CAMPBELLTOWN ROAD UPGRADE

Camden Valley Way – Brooks Road Submissions Report

MAY 2014

Figure 3.4: Landscape plan of Option A showing retention of the original gates with the proposed shared path located behind (HBO+EMTB Urban and Landscape Design 2013b)

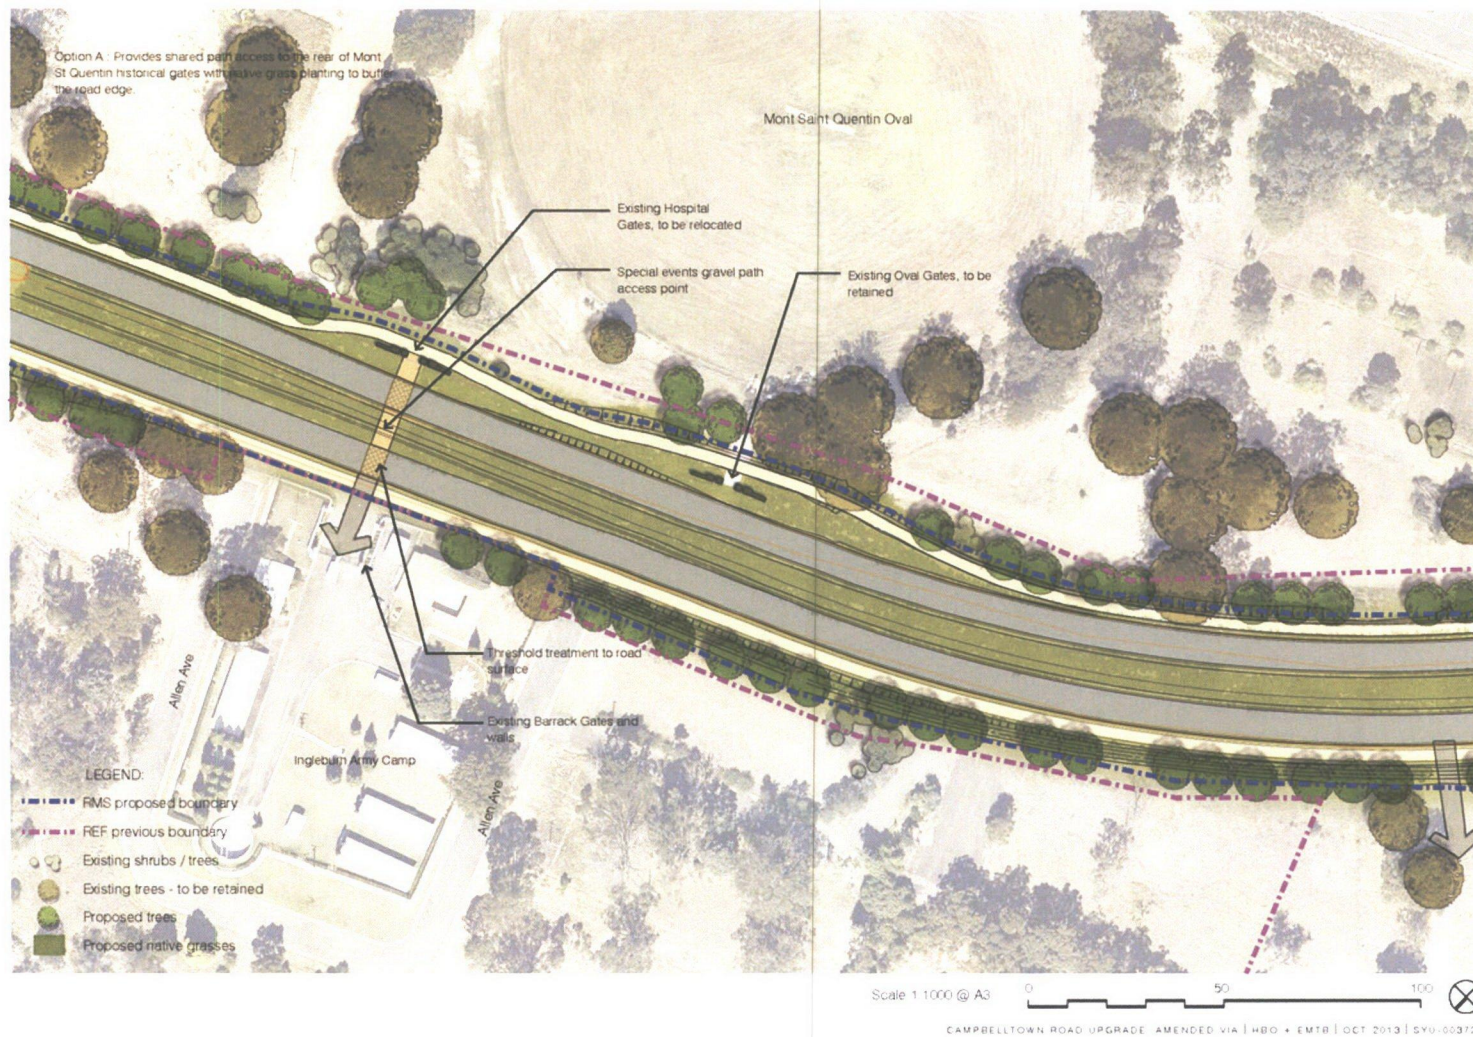
Option B (figures 3.6 and 3.7) would require the relocation of both the existing hospital gates and the existing oval gates further south, allowing the existing oval gates to continue to be used as an entrance to the oval. This option would also allow for a connecting pathway to the existing hospital gates opposite the Bardia Barracks entry.

The removal and relocation of heritage fabric within an SHR area would require a Section 60 permit. As outlined in the REF, further consideration of the configuration of the shared path and both sets of entry gates to St Mont Quentin Oval would be carried out in detailed design. The preferred option would be determined during detailed design in consultation with OEH (Heritage Branch).

Figure 4-1i: Campbelltown Road upgrade - Camden Valley Way to Beech Road

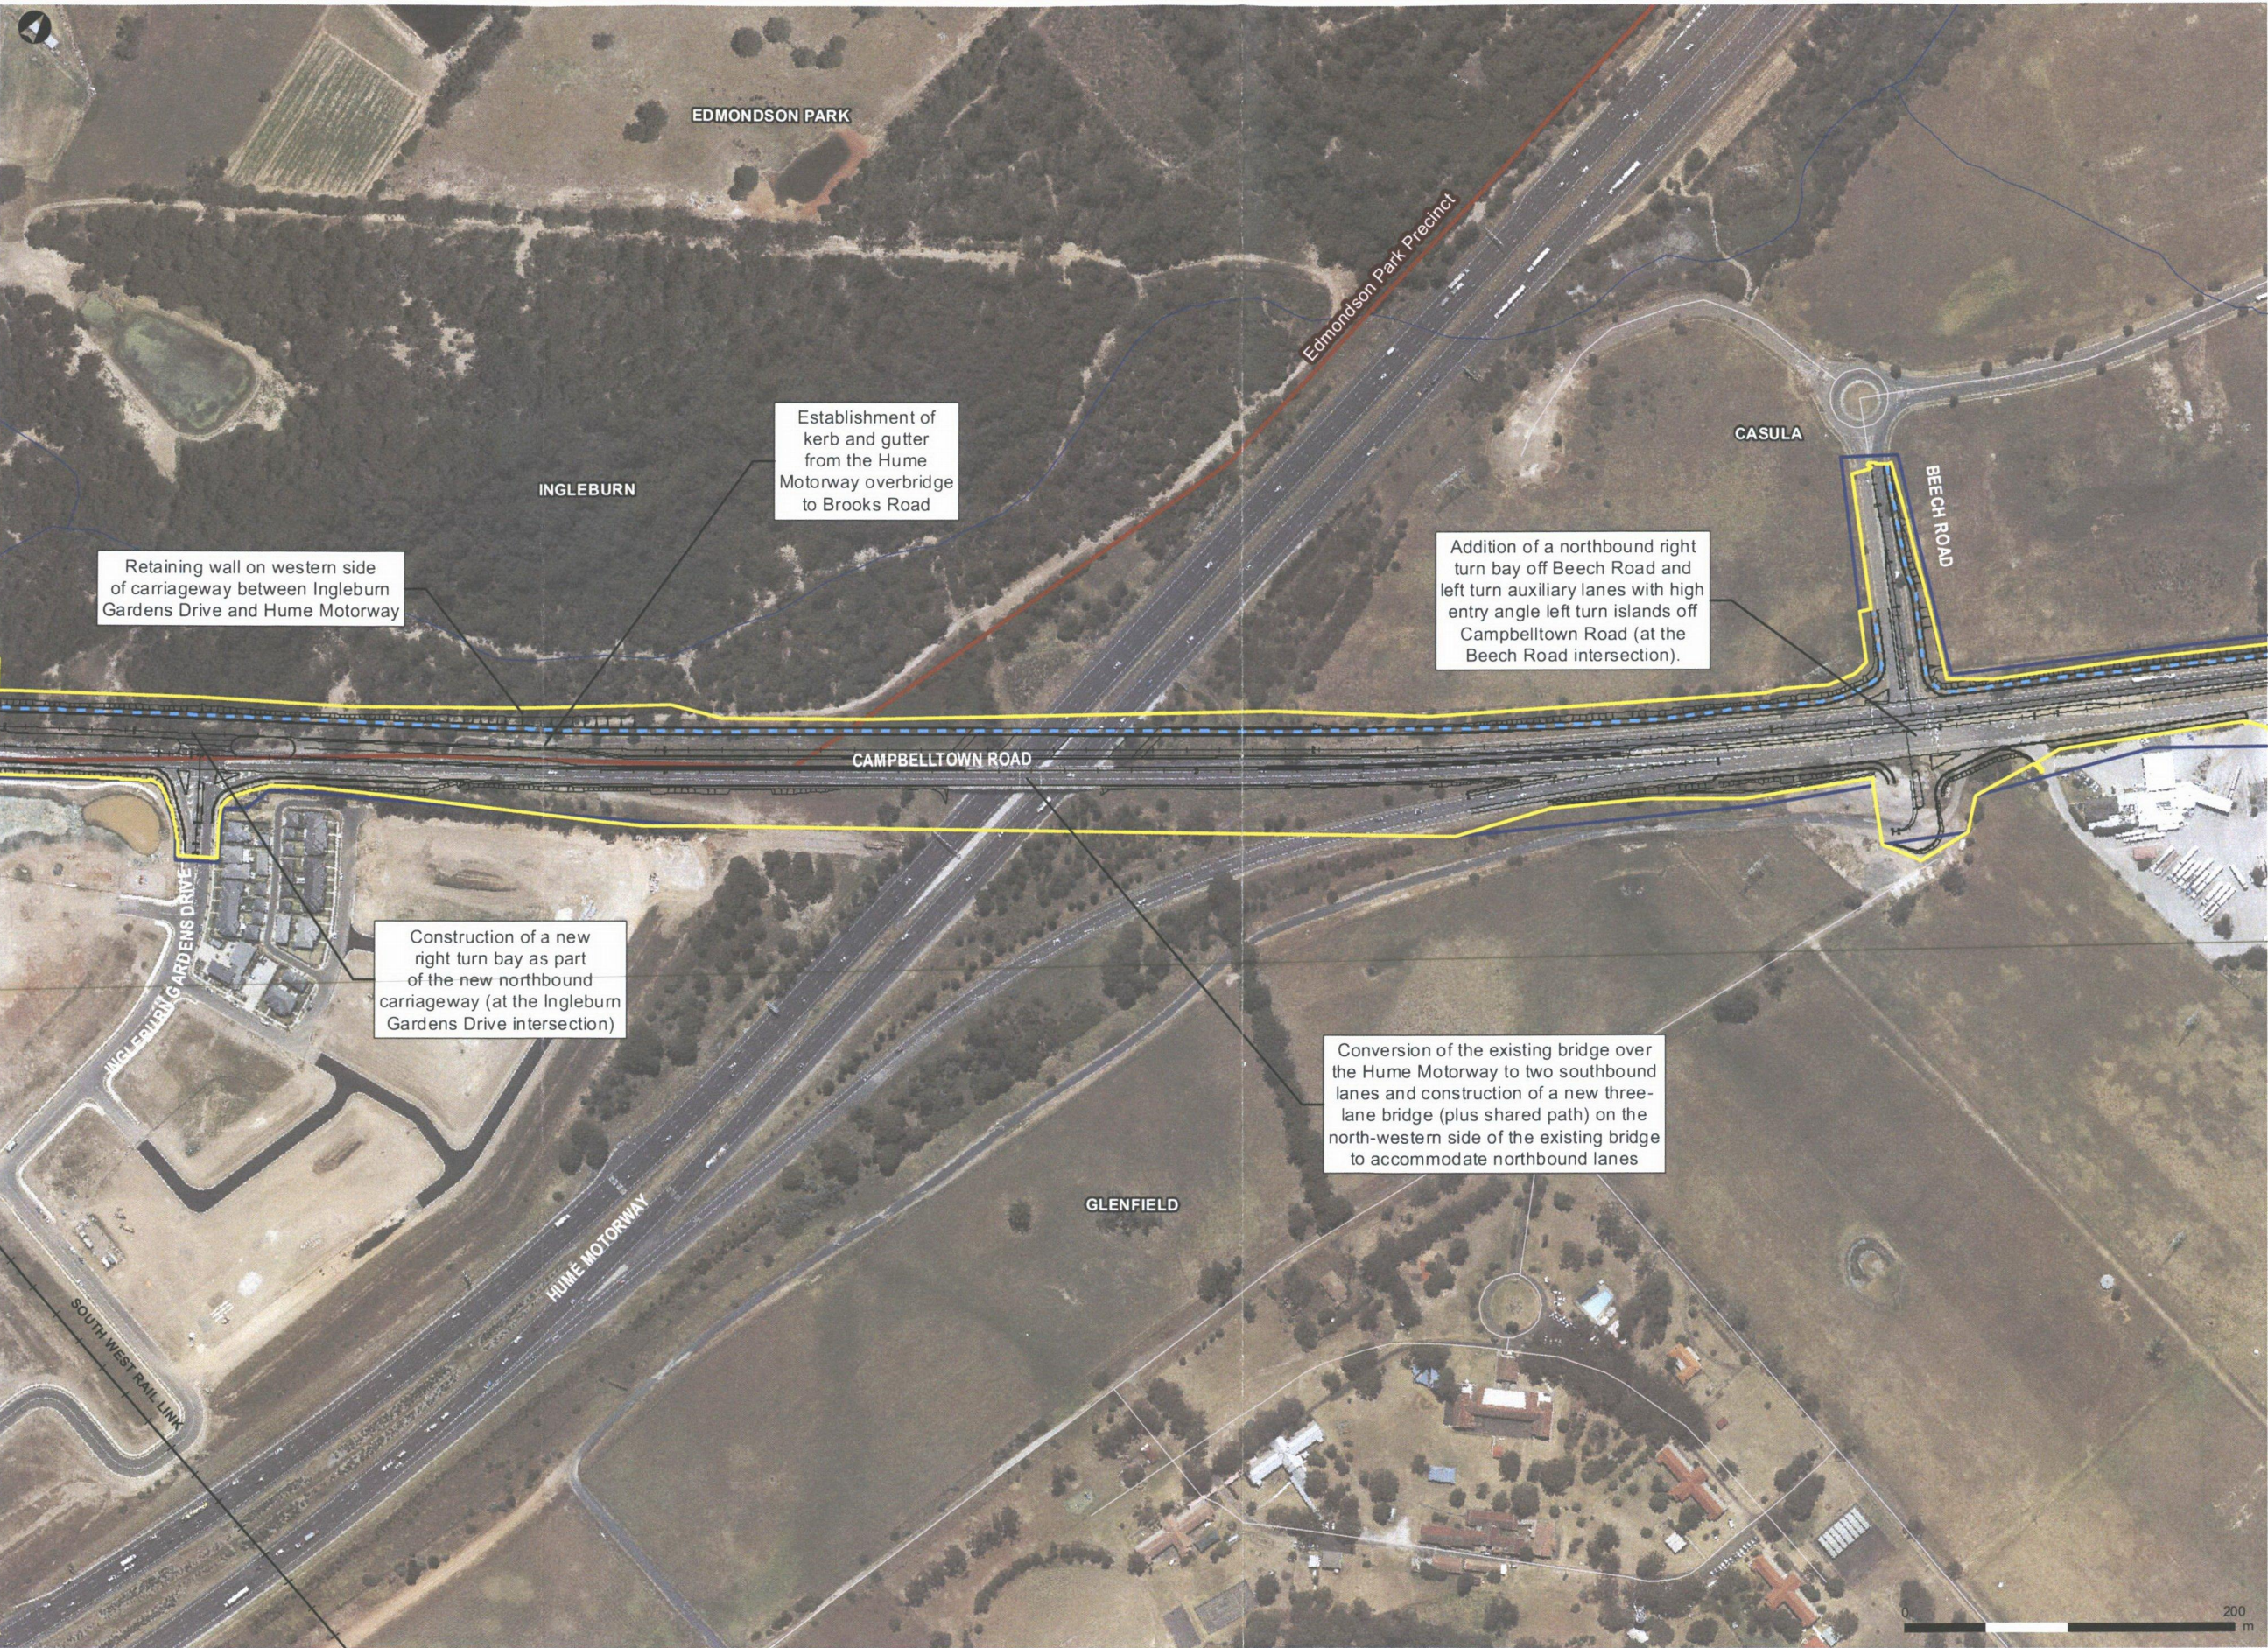
In response to community feedback on the REF, Roads and Maritime has reviewed the concept design of the proposed Campbelltown Road upgrade. The revised design and proposal area are presented in Figure 4.1 i–iv, which also includes the REF proposal area for comparison. Specific details and environmental assessment of changes to the proposal are provided in sections 4.1–4.7.

Figure 4-2: Indicative cross sections of proposed upgrade

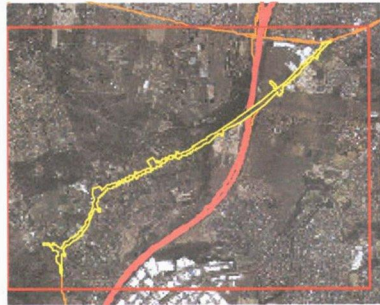
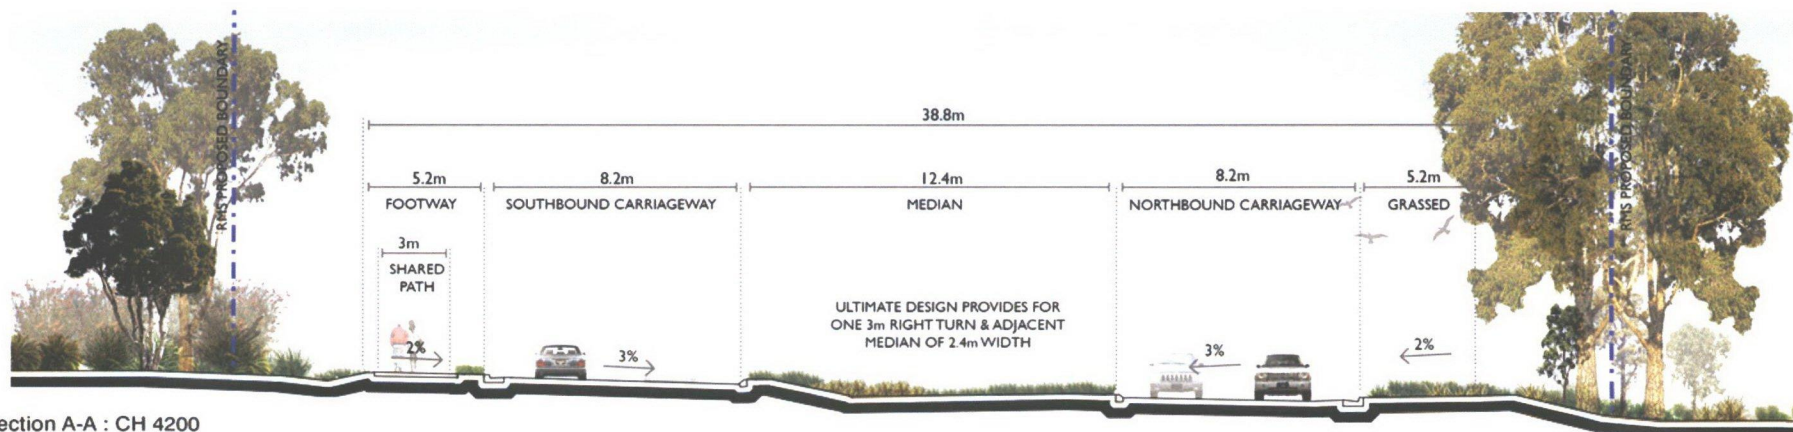
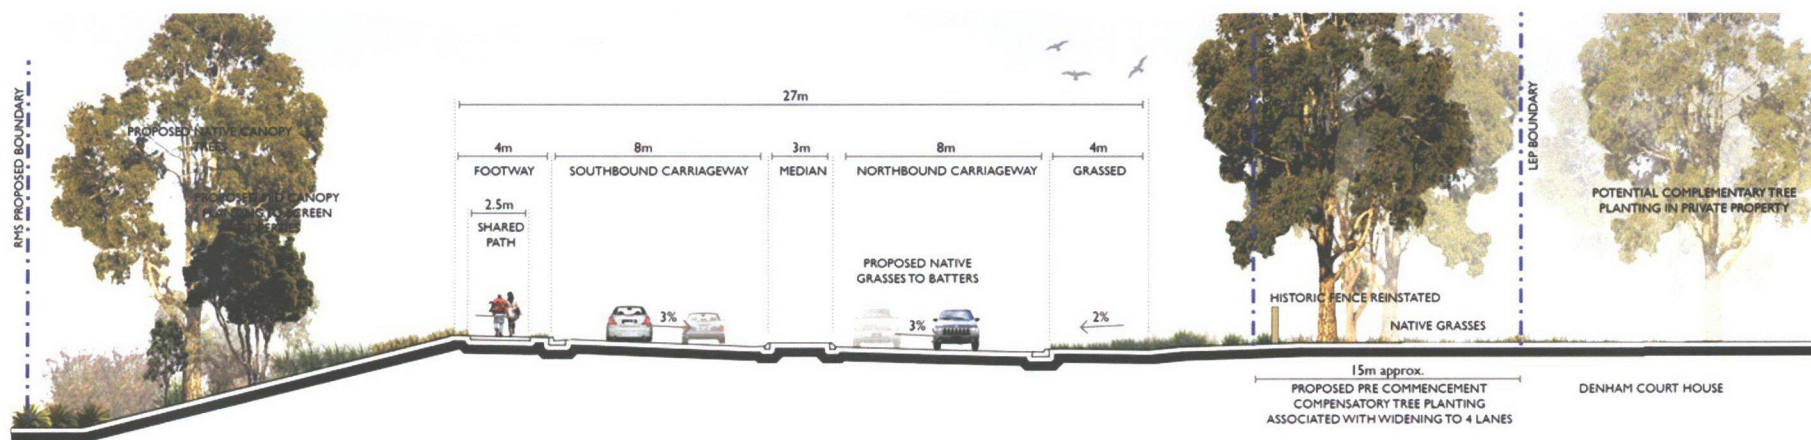
The concept design presented in the REF comprised a road corridor 44.3 to 56.4 metres wide. The revised concept design comprises a corridor width of 41.3 to 53.1 metres. The minimum corridor width as described in the REF is compared to the revised concept design for different sections of the proposal in Table 4.1 and indicative revised cross-sections are presented in figures 4.2–4.5.

Figure 4.7: Proposed intersection upgrade – Denham Court Road and Dickson Road

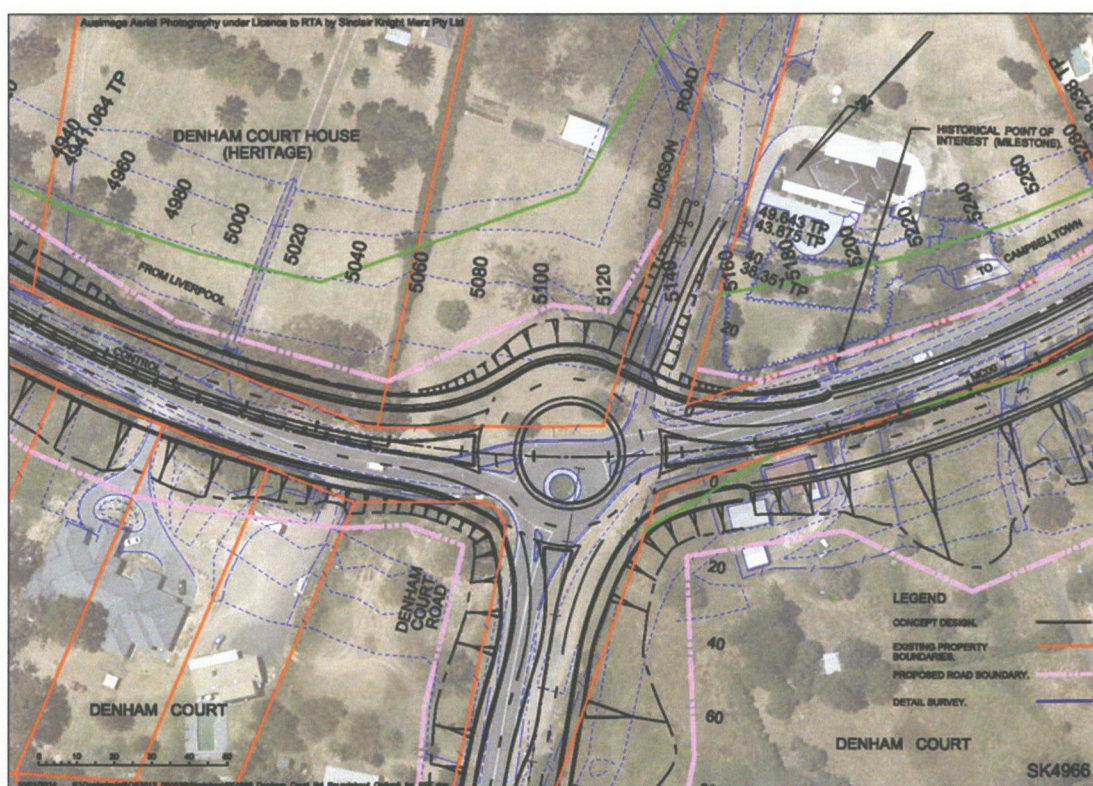
In response to community submissions on the REF, and as part of the revised concept design, a two-lane roundabout would replace the proposed intersection at Denham Court Road and Dickson Road. This would improve access to the northbound carriageway from Blomfield Road, and improve access to Denham Court Caravan Park, the BP service station and nearby local businesses from the southbound carriageway. There would no longer be widening into Dickson Road to accommodate a turnaround bay. The proposed intersection arrangement is shown in Figure 4.7.

Figure 4.8: Proposed intersection upgrade – Blomfield Road

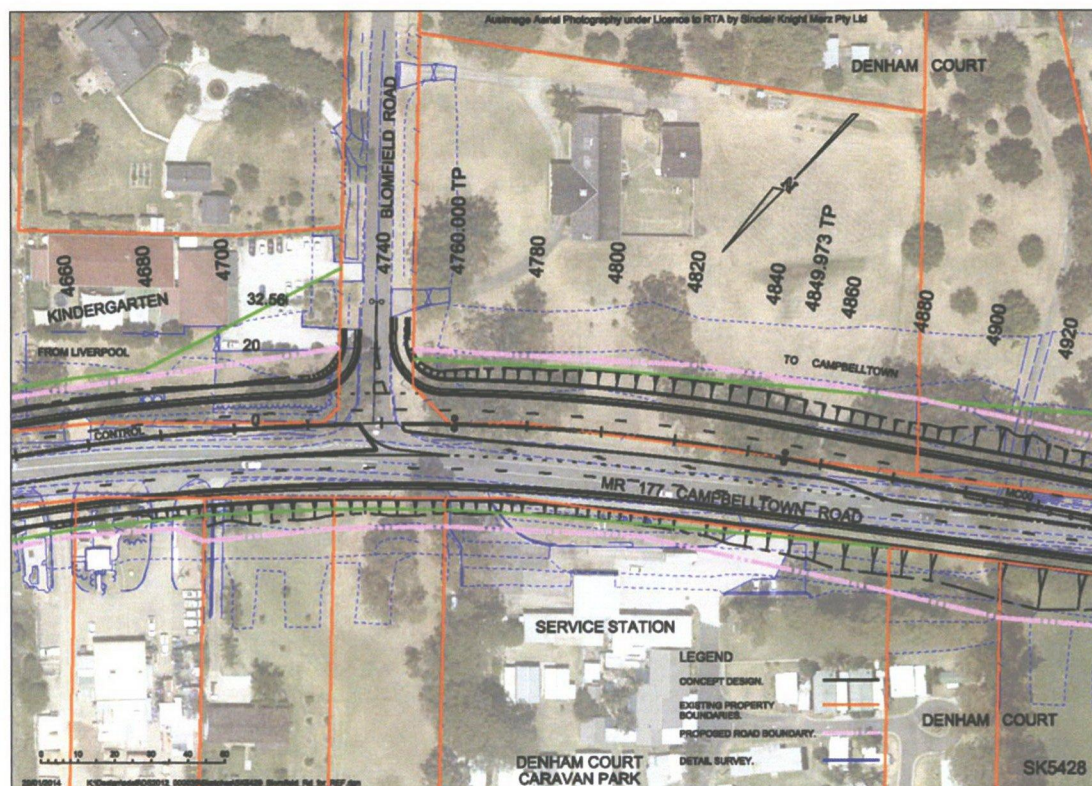
As part of the revised concept design, a right turn into Blomfield Road from the northbound carriageway of Campbelltown Road would be provided through a dedicated right-turn bay. The proposed intersection is shown in Figure 4.8.

Roads and Maritime found that allowing right-turn movements from the northbound carriageway of Campbelltown Road into Blomfield Road could be safely accommodated in the median, and this option was therefore adopted. This design change is detailed in Chapter 4 and presented in Figure 4.8. Under this design change, direct access to Blomfield Road and the Leaping Learners Early Education Centre would be possible by a right-turn lane into Blomfield Road.
